**RE: San Diego Gas & Electric Company's Response to Notice of Data Inaccuracy –
NODI_PAD_SDGE_SIS_20251008_1332**

A. Data Inaccuracy 1 – Inaccurate Data Provided on Covered Conductor Installation

Figure 1: Excerpt from design Construction Sketch for P612194, where the scope of work only required the removal of a span of wire from P612194 to P102233, and the removal of P102233.

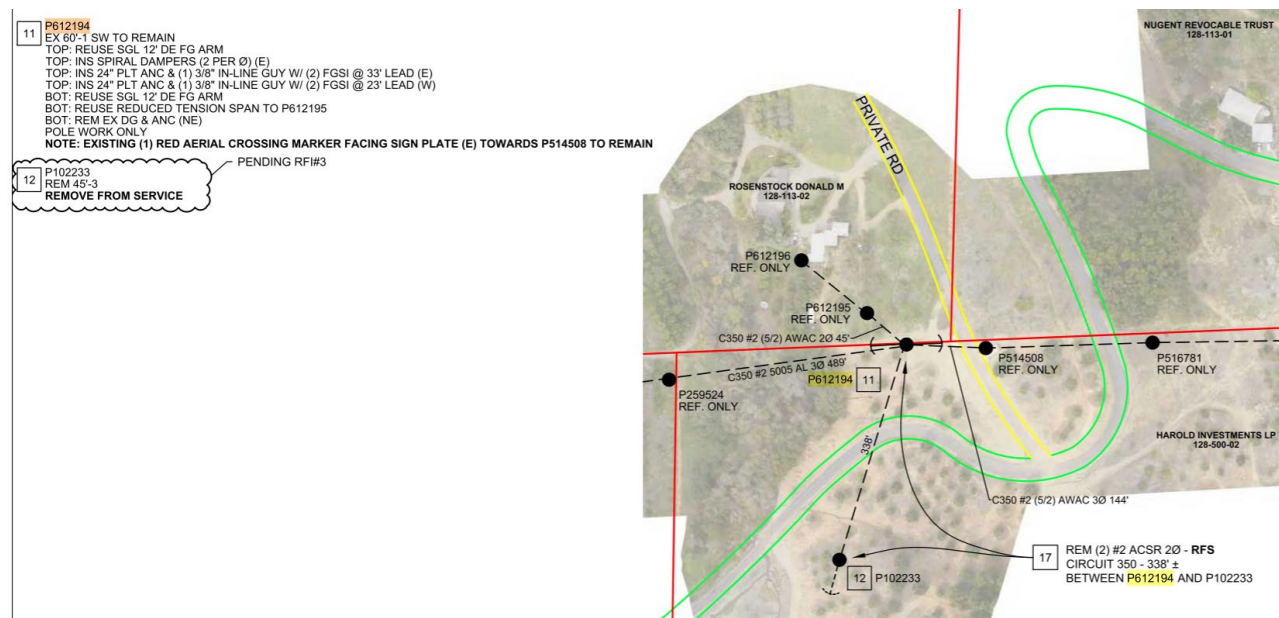
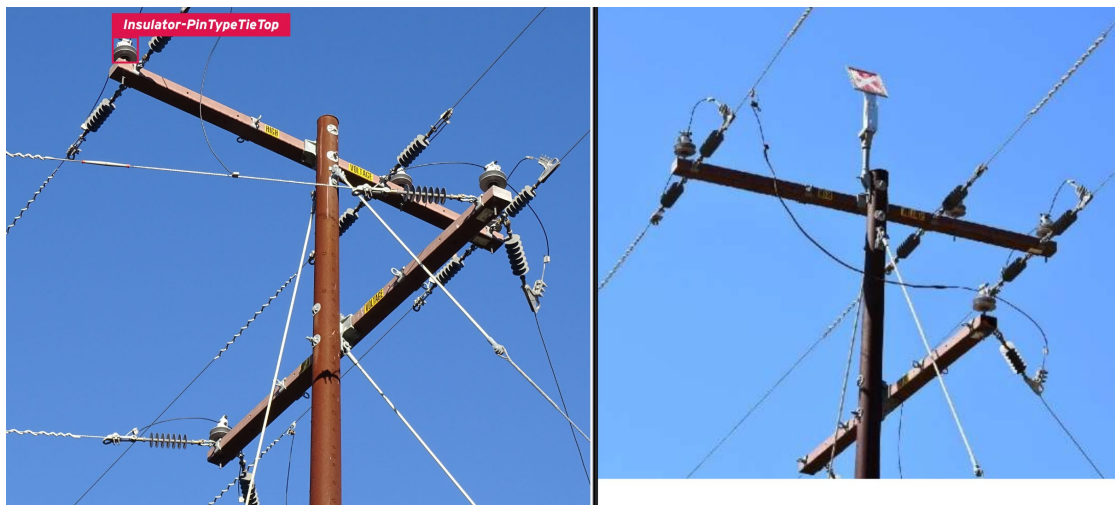
Data Inaccuracy 1. On Pole ID P612194, Grid Hardening ID P612194_0350-L-CC_83638 at coordinates 33.3146668789374, -117.102580, the inspector observed that SDG&E failed to provide accurate data.

The scope of work at location P612194 was to remove a span of bare conductor between the subject pole and a pole to the southwest because there was no longer a load to serve. The remaining bare conductor was to remain in place as the section of the circuit was previously hardened as part of the Fire Risk Mitigation (FiRM) program in 2018. Figure 1 below is from the design Construction Sketch, where the span was removed (location 17) between location 11 (P612194) and location 12 (P102233).

Accordingly, SDG&E respectfully submits that it did indeed provide accurate data contrary to the finding in the NODI. Specifically, in its Q2 QDR, SDG&E reported in the Grid Hardening Point feature class the pole (GHID:P612194_0350-L-CC_83638) had a Description of Work as Modified and the associated line segment in the Grid Hardening Line feature class (GHID: Removed_0350-L-CC_91724) had a Description of “Work as Removed” and as discussed above, this is exactly what was completed as the scope of work. SDG&E did not install covered conductor at this location and did not report that it did so.
